A REPAIR

## Septic Repair ON-SITE SEWAGE DISPOSAL SYSTEM HOWARD COUNTY HEALTH DEPARTMENT BUREAU OF ENVIRONMENTAL HEALTH

ADDRESS: 2157 Mount View Road PROPERTY OWNER: Steven and Judith Plotz

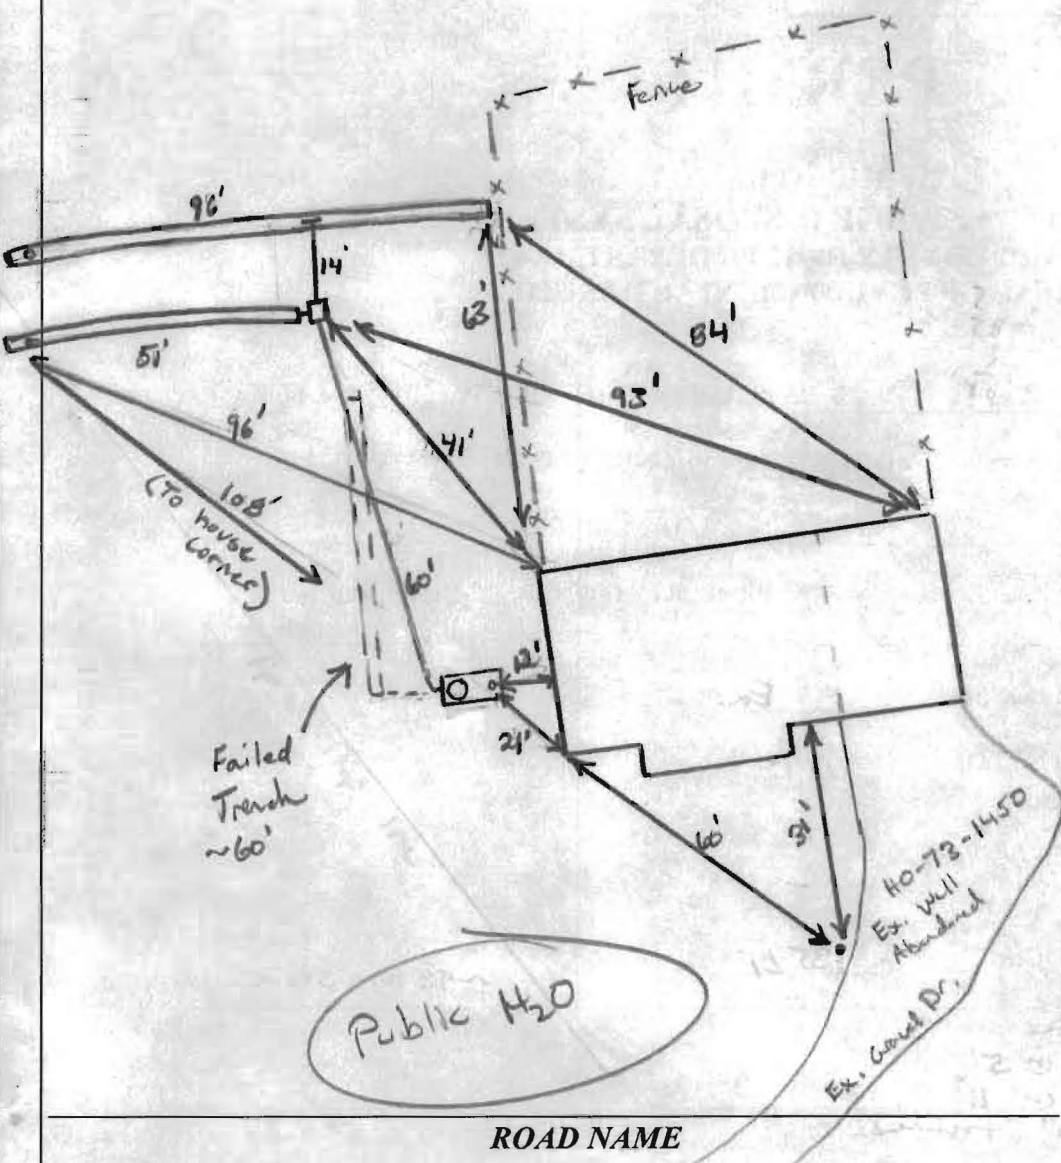
TRENCHES:	<u>2' wide Inlet @ 5' Bottom @ 11'</u>
LOCATION:	<u>2 x 68' trenches</u>
PURPOSE:	<u>Ex. trench to be abandoned. Manhole access required on ex. S.T. obs pipes required on trenches. Homeowner notified of abandoned well. Needs to be sealed.</u>

INSTALLATION: 8/24/12 Contractor worked on 8/23 when he clearly stated he was not going to complete trenches and all tie-ins. Dbox leveled, mentioned to homeowner well needs to be sealed by MD licensed Driller. OK to cover all work (PK)
